## Errata Sheet V1.0

Internal Product  
Reference 56544C

AT91  
ARM® Thumb®  
Microcontrollers

AT91M42800A  
Errata Sheet  
V1.0

**Figure 1. NWAIT Rising**

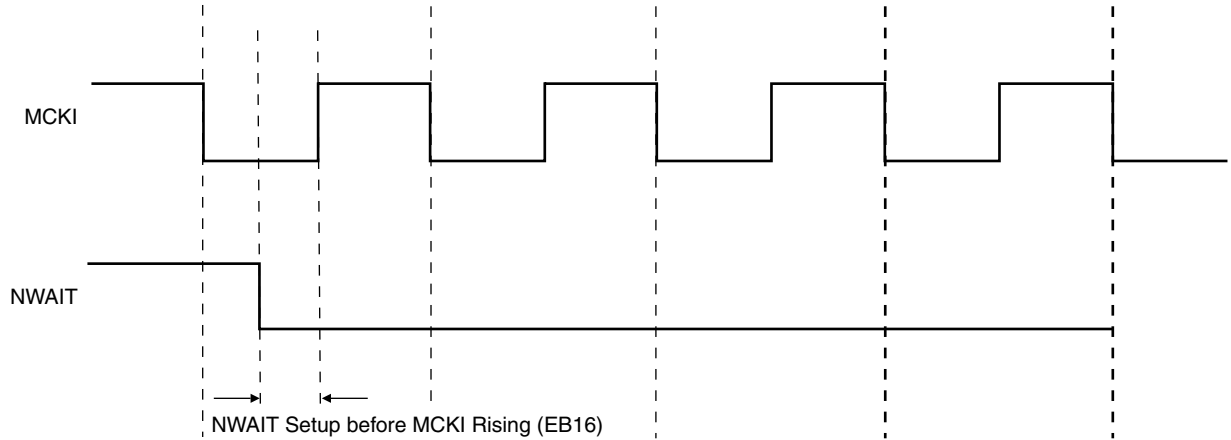
If the NWAIT setup time is satisfied on the first rising edge of MCKI, the behavior is accurate. The EBI operations are not affected when the NWAIT rises.

**Figure 2. Number of Standard Wait States is Two**

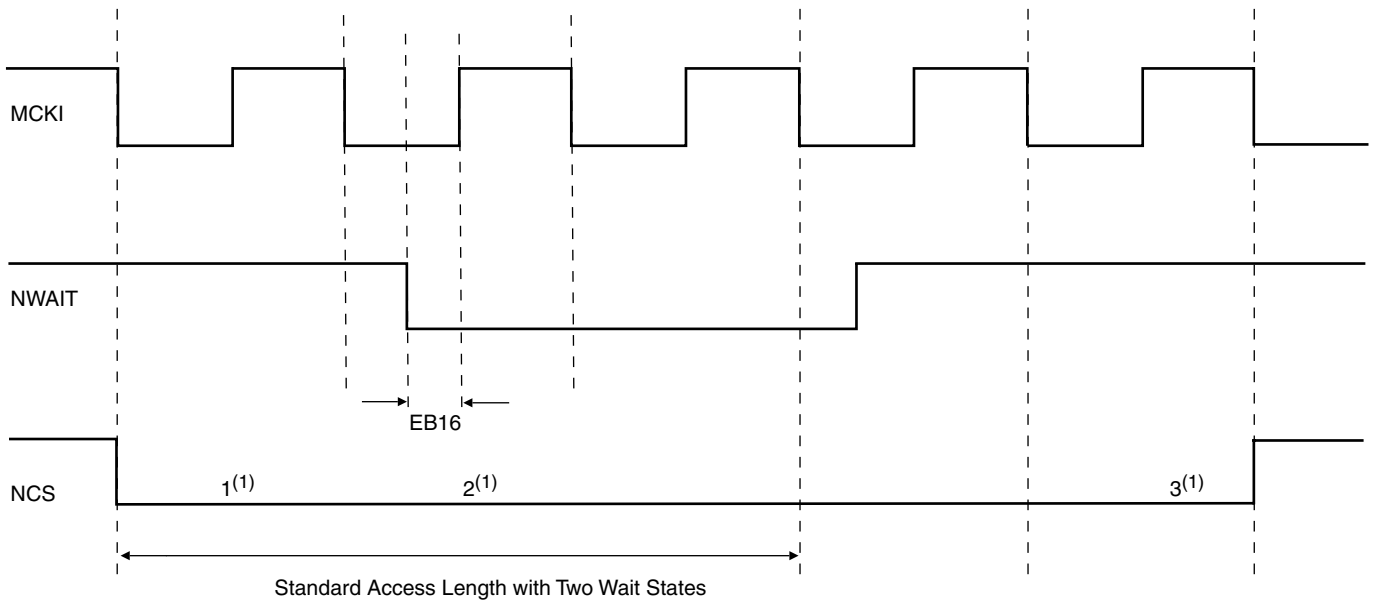
If the NWAIT setup time is satisfied on the following edges of MCKI and if at least one standard wait state remains to be executed, the behavior is accurate. In the following example, the number of standard wait states is two. The NWAIT setup time on the second rising edge of MCKI must be met.

**Figure 3.** Number of Standard Wait States is One

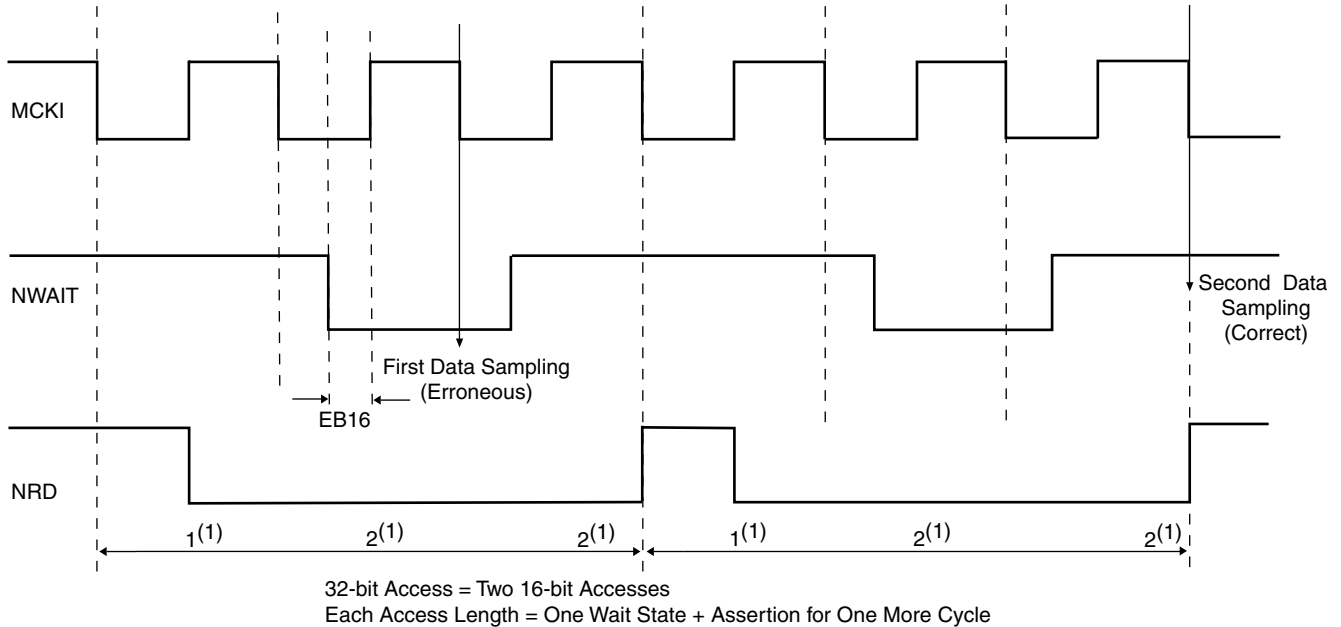
If the first two conditions are not met during a 32-bit read access, the first 16-bit data is read at the end of the standard 16-bit read access. In the following example, the number of standard waits is one. NWAIT assertions do affect both NRD pulse lengths, but first data sampling is not delayed. The second data sampling is correct.

At maximum speed, asserting the NWAIT in the first access cycle is not possible, as the sum of the timings “MCKI Falling to Chip Select” and “NWAIT setup to MCKI rising” are generally higher than one half of a clock period. This leads to using at least one standard wait state. However, this is not sufficient except to perform byte or half-word read accesses. Word and write accesses require at least two standard wait states.

**Figure 4.** Description of the Number of Standard Wait States

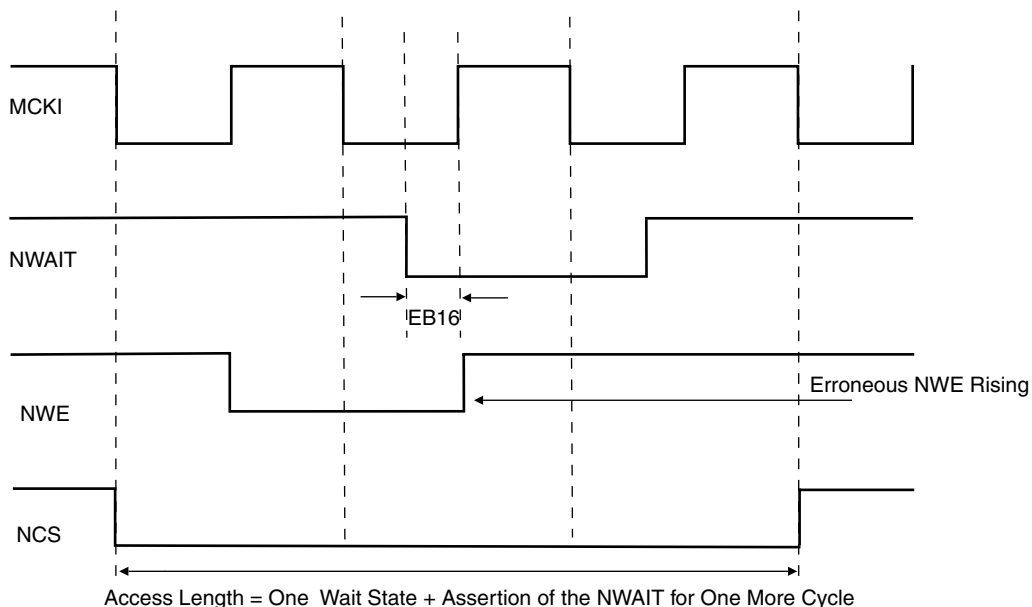
If the first two conditions are not met during write accesses, the NWE signal is not affected by the NWAIT assertion. The following example illustrates the number of standard wait states. NWAIT is not asserted during the first cycle, but is asserted at the second and last cycle of the standard access. The access is correctly delayed as the NCS line rises accordingly to the NWAIT assertion. However, the NWE signal waveform is unchanged, and rises too early.
